Access Compliance Report

Public Rights-of-Way

Intersection ID: 47468	Main Street: MILLSTREAM RIDGE DR	Cross Street: ELENDIL LN	Location: NE
ADA ID: EAE1A69998F0	Ramp Type: Perp	Initial Pass/Fail: Fail	Overall Compliance: No
Severity Score: 46.25			
Codes/Mitigation Info/Possible Solution		Field Measurements/Component Compliance

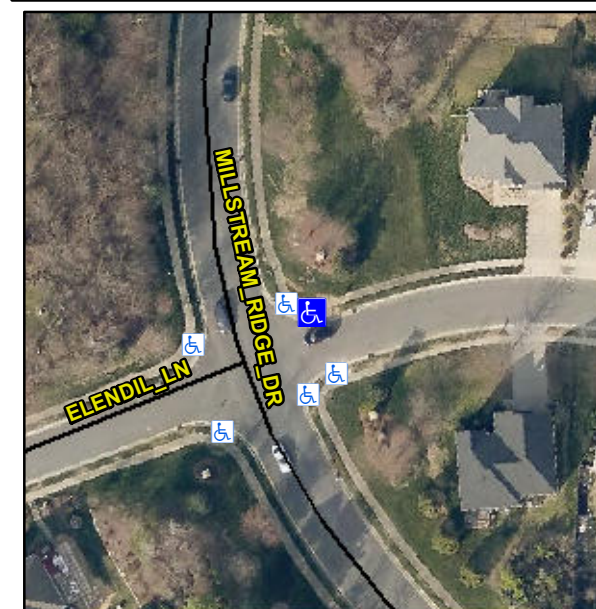
R304.5.1, R304.2.2, R304.5.3

Compliance	Description	Data	Compliance	Description	Data
N/A	Ramp Length (in)	49.0	No	Ramp Slope (%)	11.3
No	Ramp Width (in)	39.0	No	Ramp XSlope (%)	7.5
N/A	Flare Type LT	N/A	N/A	Flare Type RT	N/A
N/A	Flare Slope LT (%)	N/A	N/A	Flare Slope RT (%)	N/A
N/A	Flare Traversable LT?	N/A	N/A	Flare Traversable RT?	N/A
N/A	Landing Length (in)	N/A	N/A	DWS Provided?	N/A
N/A	Landing Width (in)	N/A	N/A	DWS Contrast?	N/A
N/A	Landing Slope (%)	N/A	N/A	DWS Length (in)	N/A
N/A	Landing X Slope (%)	N/A	N/A	DWS Full Width?	N/A
N/A	Landing Curb? (Y/N)	N/A	N/A	DWS Offset (in)	N/A
N/A	Shared Landing?	N/A			
N/A	Gutter Ponding?	N/A	N/A	Gutter Slope (%)	N/A
N/A	Gutter Lip Ht (in)	N/A	N/A	Gutter X Slope (%)	N/A
N/A	Painted X Walk1?	No	N/A	Painted X Walk2?	N/A
	X Walk 1 Direction	To S		X Walk 2 Direction	N/A
N/A	X Walk 1 Width (in)	N/A	N/A	X Walk 2 Width (in)	N/A
	X Walk 1 Slope (%)	8.8		X Walk 2 Slope (%)	N/A
	X Walk 1 X Slope (%)	6.2		X Walk 2 X Slope (%)	N/A

Remove & Replace Entire Ramp.
